# MONITORING YEAR 5 ANNUAL REPORT

## VILE CREEK MITIGATION SITE

Alleghany County, NC  
DEQ Contract No. 5999  
DMS Project No. 96582

RE: **Response to MY5 Draft Report Comments**  
**Vile Creek Mitigation Project**  
DMS Project # 96582  
Contract Number 5999  
New River Basin - HUC# 05050001 - Alleghany County, North Carolina

**Monthly Rainfall Data**

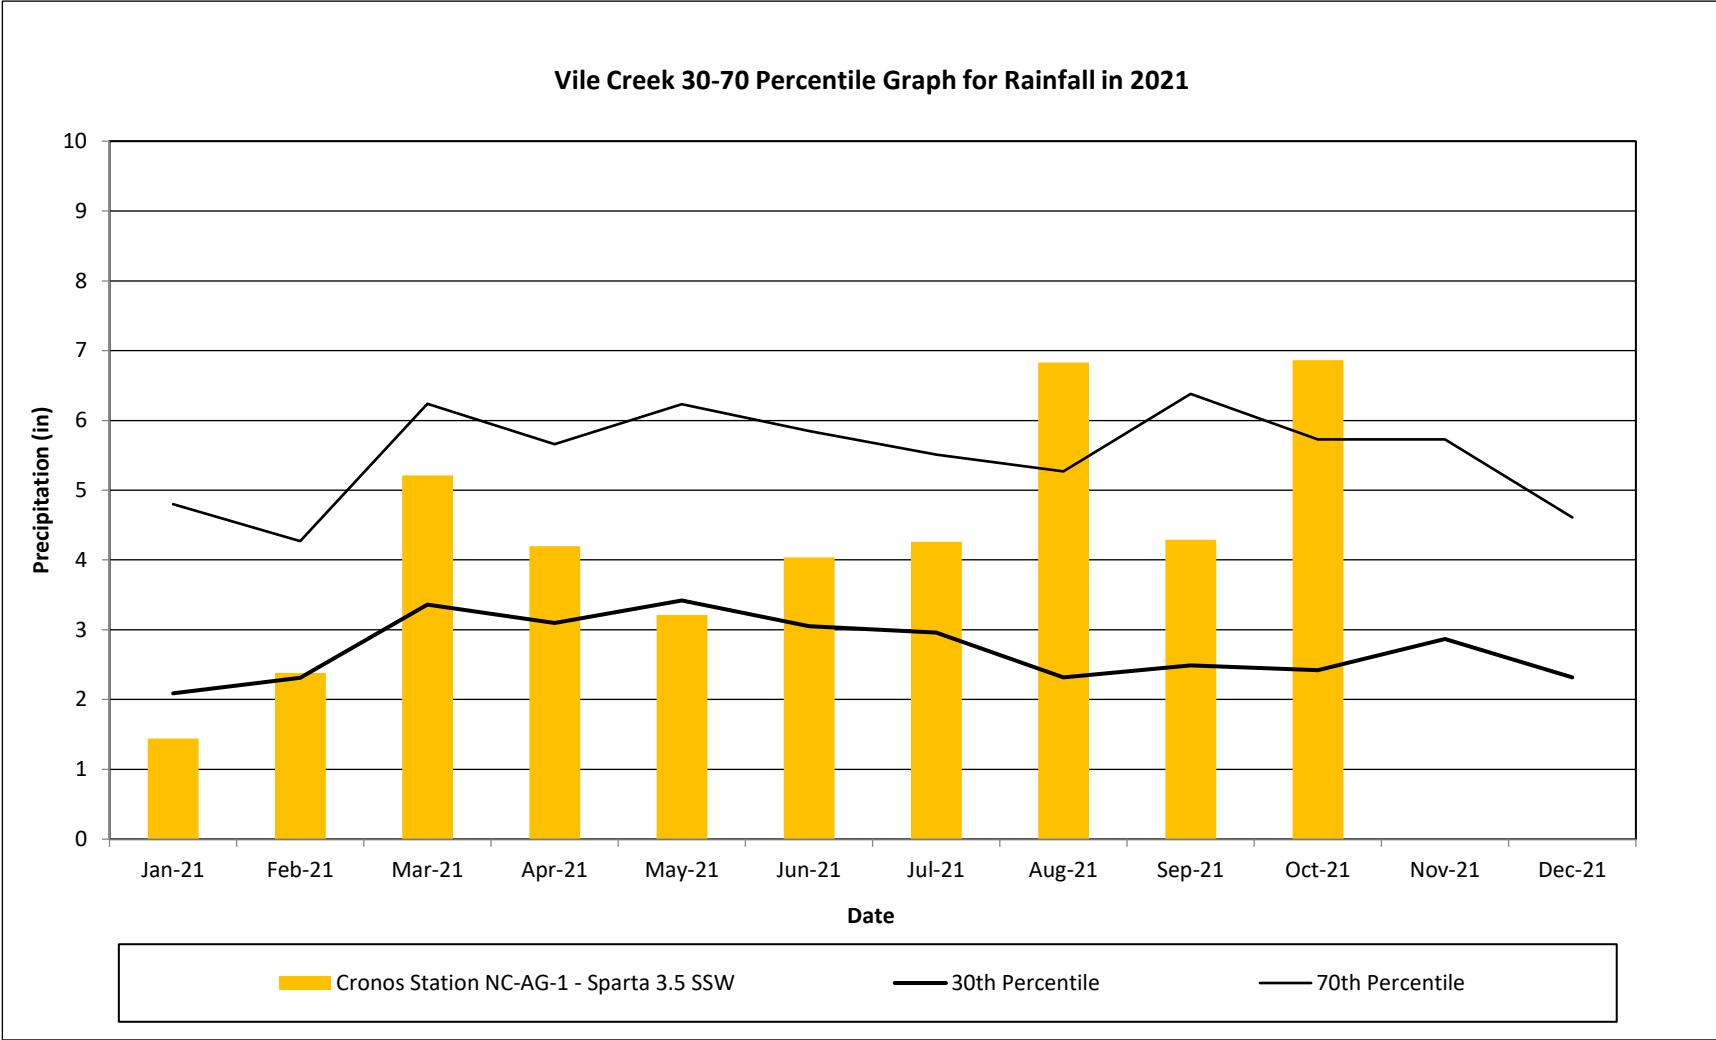
**DMS' Comment:** Please submit the data used to create the 30-70 figure.

*Wildlands' Response:* The data used to create the 30-70 figure is included in the Rainfall-Sparta 3.5 SSW folder. The CSV file was renamed to 30-70 figure.
